CITY OF ALBUQUERQUE

September 27, 2023

Re: 417 Tramway
417 Tramway Blvd. NE
Traffic Circulation Layout
Architect's Stamp 08-27-23 (K23-D020)

SITE PLAN

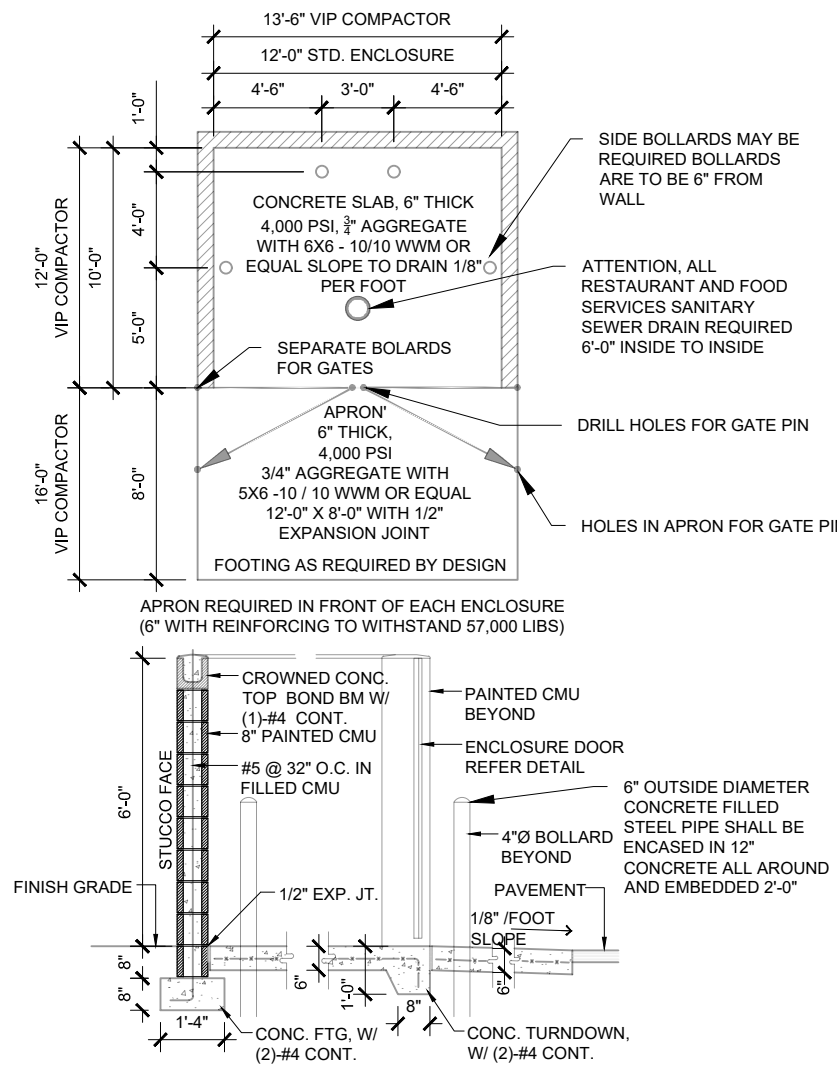
1. Identify all existing access easements and rights of way width dimensions.
2. Identify the right of way width, medians, curb cuts, and street widths on Tramway Blvd., Cloudview Ave., and Panorama Pl.

3. Please provide a brief of work scope and project information.
4. Please show on the site plan the distance from the intersection to the site accesses.

5. Please show on the site plan the main entrance for the proposed Day Care.
6. All three site accesses and ADA ramps must be updated to current standards and have truncated domes installed.

7. Please provide the width for all the existing site accesses.
8. Per the IDO, a 6 ft. wide ADA accessible pedestrian pathway is required from the public sidewalk to the building entrances. Please clearly show this pathway and provide details.

9. Per DPM, a 6 ft. wide ADA accessible pedestrian pathway is required from the ADA parking stall access aisles to the building entrances. Please clearly show this pathway and provide details.

10. ADA accessible pedestrian pathway should not be placed behind parking space or adjacent to a vehicular way. Vehicle and pedestrian/wheel chair conflicts should be avoided as much as possible.

11. Define the ADA pathway from the public sidewalk to the building entrance by labeling flush or ramp.
12. Please list the width and length for all existing and proposed parking spaces. Some dimensions are not shown.

14. Please provide the width for the existing drive aisle.

15. Provide "ONE WAY" sign and pavement marking at the beginning of the drive-thru.
16. Show on the site plan the drive-thru radius.
17. The minimum drive through lane width is 12 feet with a 25-foot minimum radius (inside edge) for all turns. (A 15-foot radius can be used with an increase in lane width to 14 feet). Please dimension all lane widths and radii.

18. Please revise keynote 25.
19. Motorcycle parking spaces shall be designated by its own conspicuously posted upright sign, either free-standing or wall mounted per the zoning code.

20. The pavement marking "MC" should be shown in the opposite direction for motorcycles entering the parking space.
21. Please provide a sight distance exhibit

22. Show the clear sight triangle and add the following note to the plan: "Landscaping and signage will not interfere with clear sight requirements. Therefore, signs, walls, trees, and shrubbery between 3 and 8 feet tall (as measured from the gutter pan) will not be acceptable in the clear sight triangle.

23. Please specify the City Standard Drawing Number when applicable.
24. Add a note stating "All broken or cracked sidewalk must be replaced with sidewalk and curb & gutter." A build note must be provided referring to the appropriate City Standard drawing.
